Knit Concern Ltd (Extension)

62, Water Works Road Godnail, Narayangonj.

22 January 2025

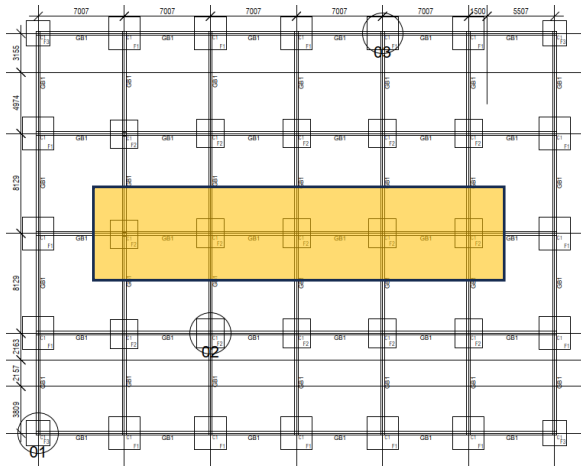
Observation 1: Stress in foundation above the normal design limit (Shed 1 Chemical Godown).

Description: Cursory calculation indicates that stress in foundation exceeds normal design limit considering the live load of 6 kPa on the 1st floor, 1 kPa on the roof sheet, allowable soil bearing capacity 1 ksf (FoS:2.5), concrete strength 14.1 MPa minimum for brick chips and considered conservative geometric properties of foundation. The building engineer is required to carry out a Detailed Engineering Assessment (DEA) to check the foundation adequacy and prepare a remedial scheme.	
Observation 2: Lack of lateral Stability of the shed (Shed 1 Chemical Godown).

Description: Lack of lateral load resistance system observed in the shed: missing compression strut, moment resisting connection in the long direction. The building engineer is required to check the lateral stability of the structure as part of DEA.	
Observation 3: Incomplete retrofitting works and as-built drawing (Shed 1 Chemical Godown).

Description: Incomplete retrofitting works were observed. Lack of information observed in the as-built drawing and there was no substructural detail in the prepared drawings. The building engineer is required to survey the structure and prepare accurate as-built drawings including the retrofitting and substructural details.

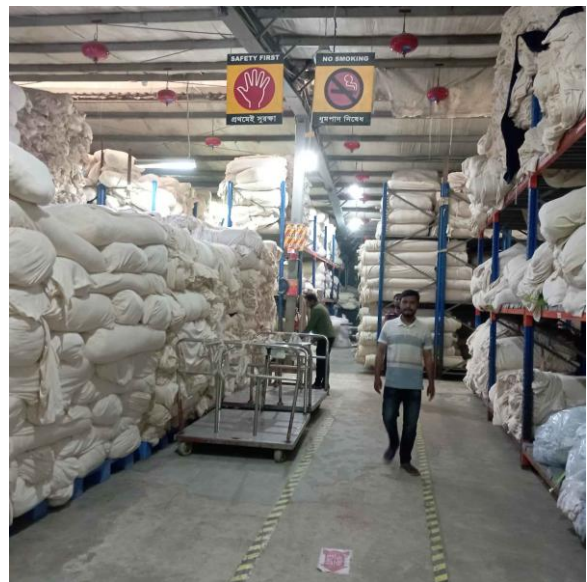
Observation 4: High stress in column and foundation that requires immediate design review (Shed 2-Row Fabric Store).

Description: Cursory calculation indicates the high stress in the column and foundation (punching) at the marked locations considering the live load of 4 kPa on the 1st floor, 1 kPa on the roof sheet, minimum steel strength (248 MPa), and minimum concrete strength (14.1 MPa).

The building engineer is required to check the column, foundation adequacy check and carry out a Detailed Engineering Assessment (DEA).

Observation 5: Lack of lateral stability (Shed 2-Row Fabric Store).

Description: Lateral load transfer media is not provided to transfer the lateral load. As part of DEA, the building engineer is required to check the lateral stability of the structure and prepare remedial scheme.

Observation 6: Column plaster damage due to trolley impact (Shed 2-Raw Fabric Store).

Description: Column plaster was found damaged due to trolley impact. The building engineer is required to repair the damaged plaster and provide the column guard to prevent trolley impact.

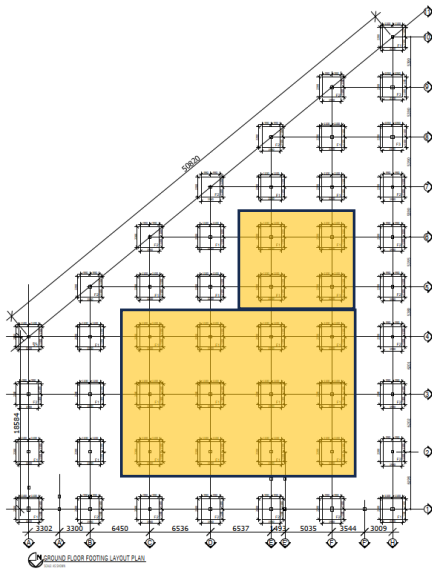
Observation 7: Non-structural elements found not anchored/braced (Shed 2-Raw Fabric Store).

Description: Nonstructural elements (storage racks) were found not anchored/braced. The building engineer is required to anchor/brace all nonstructural elements within the factory.

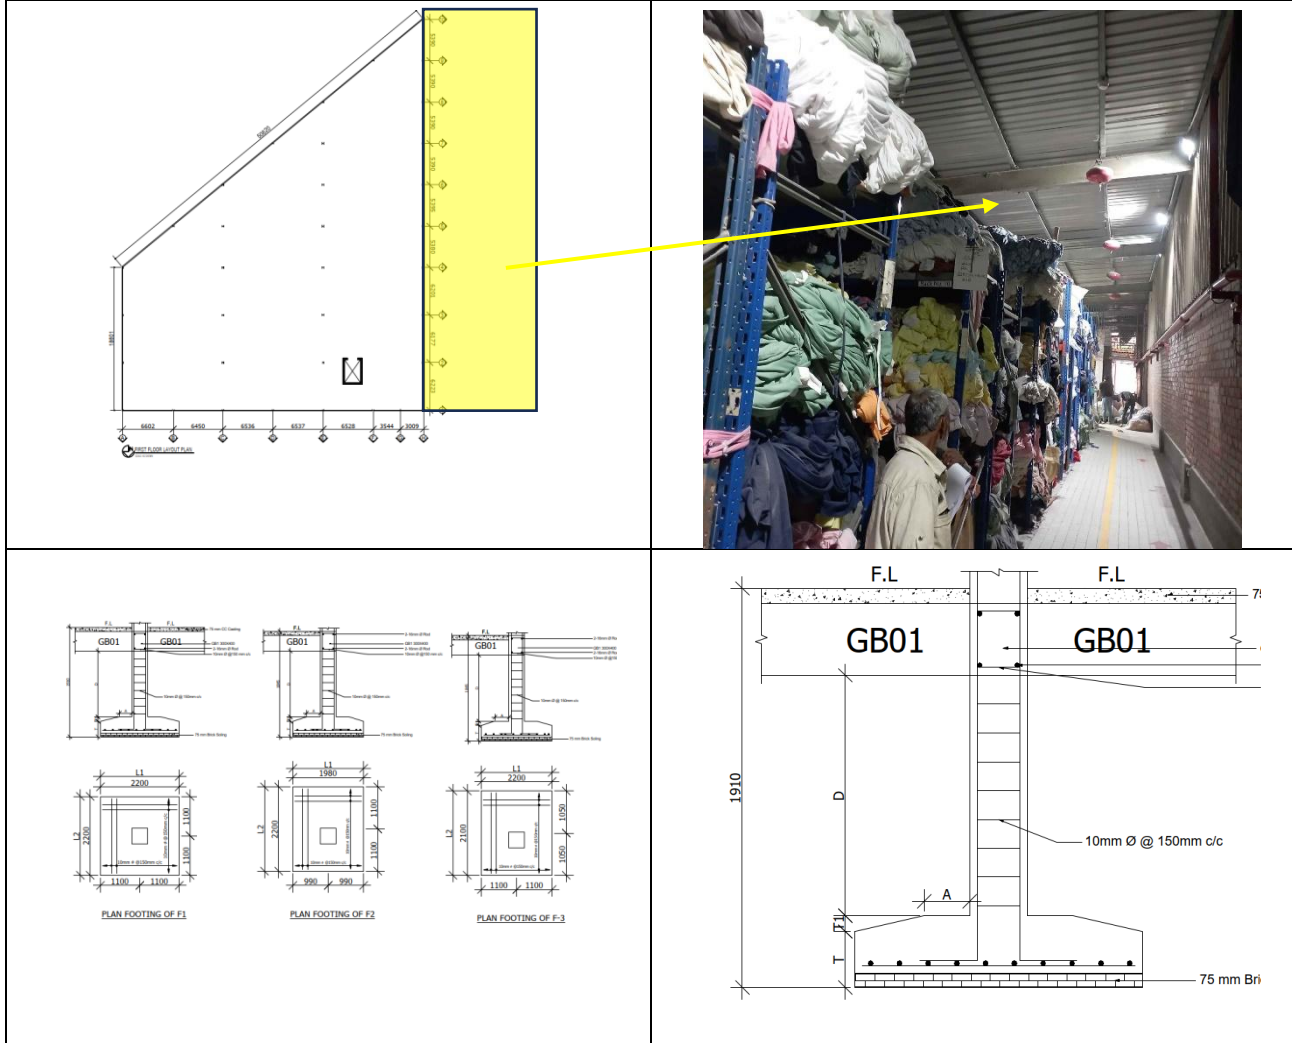
Observation 8: High stress in foundation that requires immediate design review (Shed 3 Yarn Godown).

Description: cursory calculation indicates the high stress in foundation at the marked locations considering the live load of 4 kPa on the 1st floor, 1 kPa on the roof sheet, allowable soil bearing capacity 1 ksf (FoS:2.5) assuming the footing depth 1.5 m considering the onsite condition and found of adjacent structures (footing depth from EGL not shown). The building engineer is required to carry out a Detailed Engineering Assessment (DEA) to check the foundation adequacy and prepare necessary remedial scheme.

Observation 9: Lack of lateral stability (Shed 3 Yarn Godown).

Description: Lateral load transfer media is not provided to transfer the lateral load. As part of DEA, the building engineer is required to check the lateral stability of the shed.

Observation 10: Discrepancy/missing information in as built and retrofitting drawing (Shed 3 Yarn Godown).

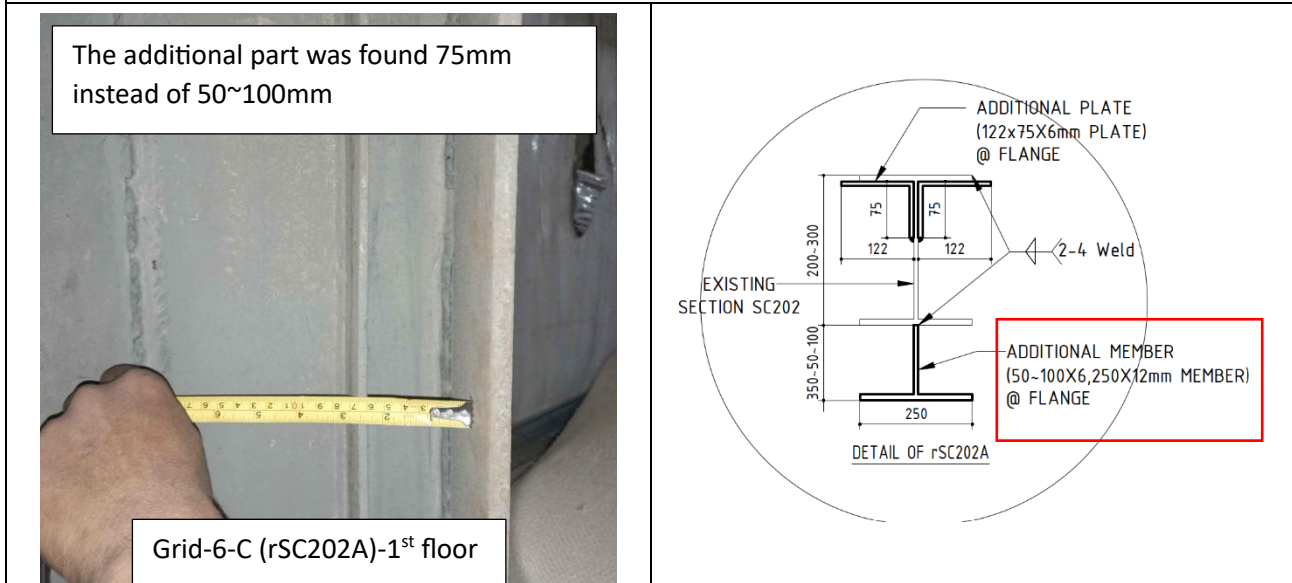
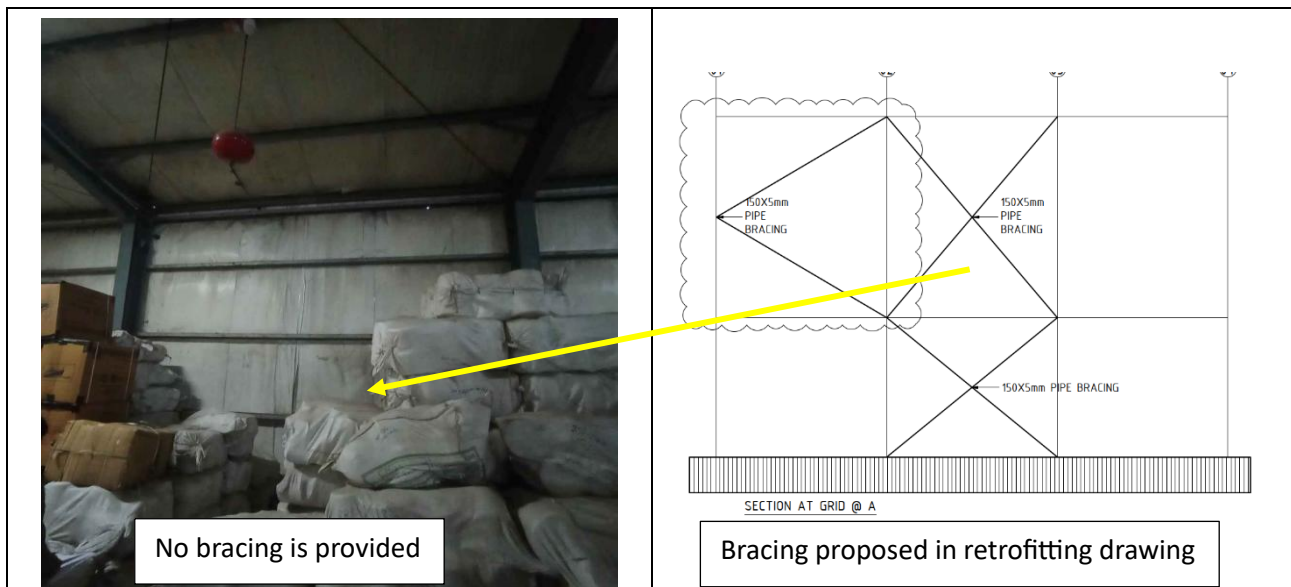
Description: An Undocumented single-storied shed was found structurally connected at the west side. The building engineer is required to update the as built drawing.

Description: Discrepancy found between retrofitting drawing and on site condition. The building engineer is required to update the retrofitting drawing.

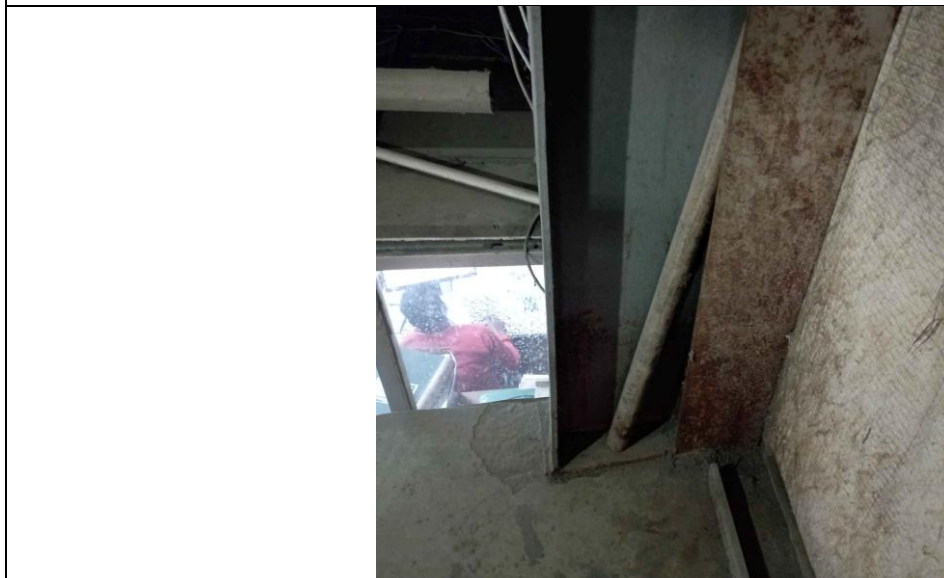
Observation 11: Corrosion on steel members (Shed 3 Yarn Godown).

Description: Corrosion was observed on steel members at several locations. The building engineer is required to remove the corrosion and provide rust-proof paint on steel members.

Observation-12: Non-structural elements found not anchored/braced (Shed 3 Yarn Godown).

Description: Nonstructural elements (storage racks) were found not anchored/braced. The building engineer is required to anchor/brace all nonstructural elements within the factory.

Foundation layout

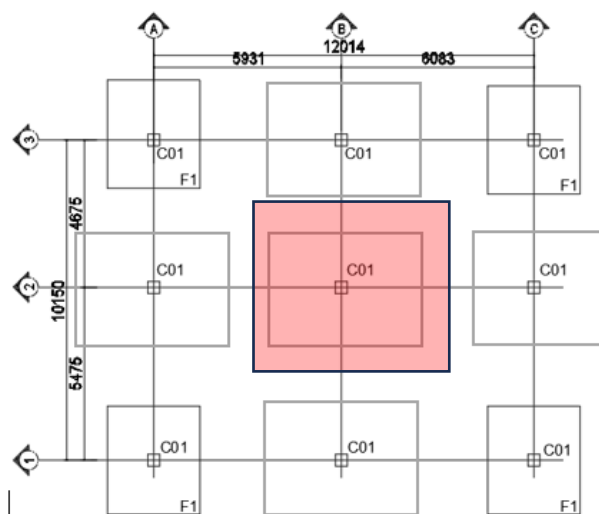
Observation 13: High stress in foundation that requires immediate design review (Shed 4 Diseal Generator & Chiller Building).

Description: Cursory calculation indicates the high stress in foundation at the marked locations considering the live load of 2 kPa on the 1st floor, 1 kPa on the roof sheet, allowable soil bearing capacity 1 ksf (FoS:2.5) assuming the footing depth 1.6 m considering the onsite condition and found of adjacent structures (footing depth from EGL not shown). The building engineer is required to carry out a Detailed Engineering Assessment (DEA) to check the foundation adequacy and prepare remedial scheme.

<u>Column layout and schedule</u>	<u>Foundation layout</u>

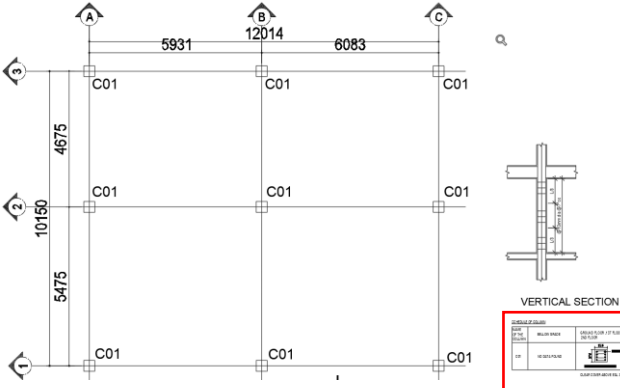
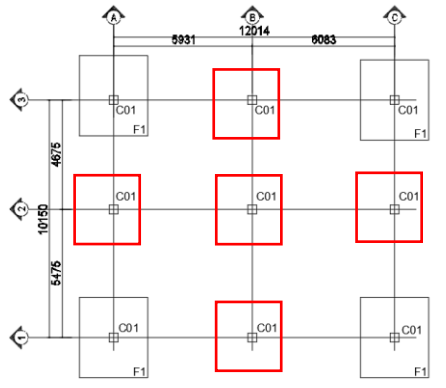
Observation 14: Incomplete as built drawing (Shed 4 Diseal Generator & Chiller Building).

PVC water tank	External steel stair
Description: During inspection a set of drawings was found on site for the structure. But pedestal column and foundation layout information were found incomplete. Also, the external steel stair and PVC water tank were not shown in the drawing. The building engineer is required to survey the full structure and prepare complete drawings also check the stability system.	
Observation 15: Lack of lateral stability (Shed 4 Diseal Generator & Chiller Building)

Corrosion on steel member of steel stair

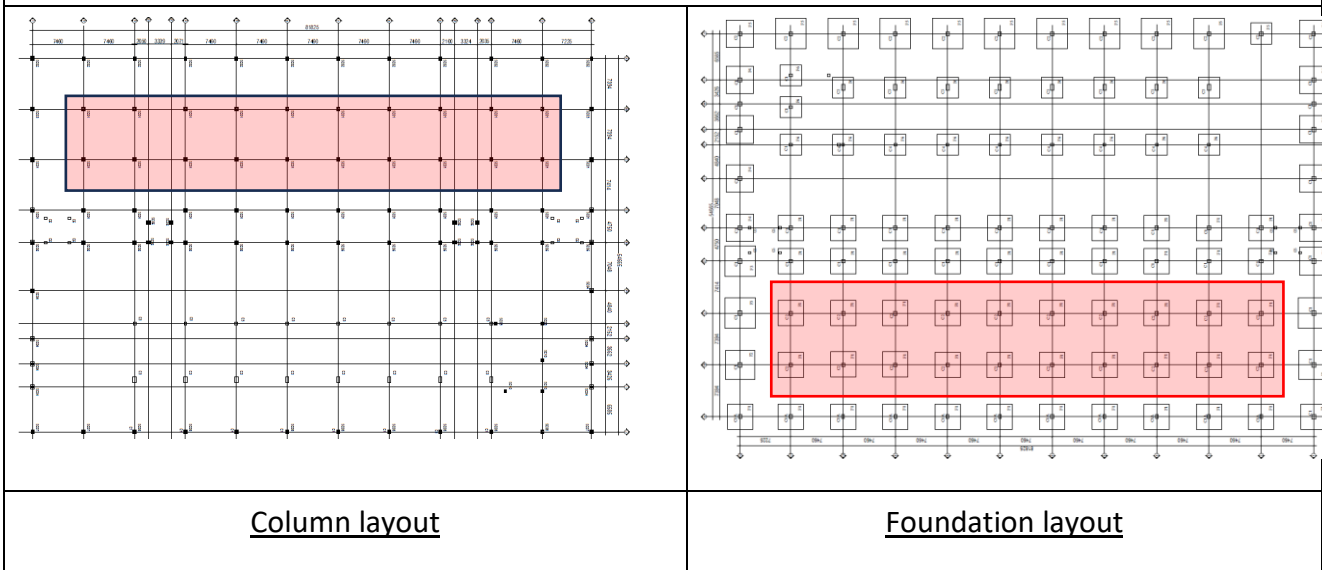
Observation 16: Severe corrosion on steel member of steel stair. (Shed 4 Diseal Generator & Chiller Building).

Description: During inspection, severe corrosion has been identified on a steel member of the steel stair. The corrosion has significantly compromised the structural integrity of the affected component, posing potential safety hazards such as reduced load-bearing capacity, material deterioration, and increased risk of failure. Remove the corrosion/rust and apply anti-corrosive coating to the affected steel member, also provide adequacy of the external steel stair based on effective plate thickness.

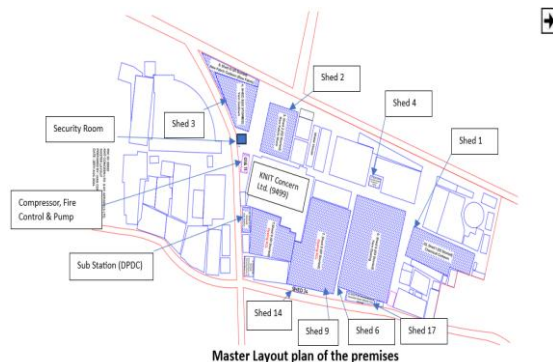
Observation-31: Unclear load path (Substation Room).

Description: The structural system of the structure was observed as a mix of flat slab and beam-column. However, at one place a beam was found as cantilevered. The load path was unclear. The building engineer is required to prepare an Engineering Assessment (EA) to check the stability of the structure.
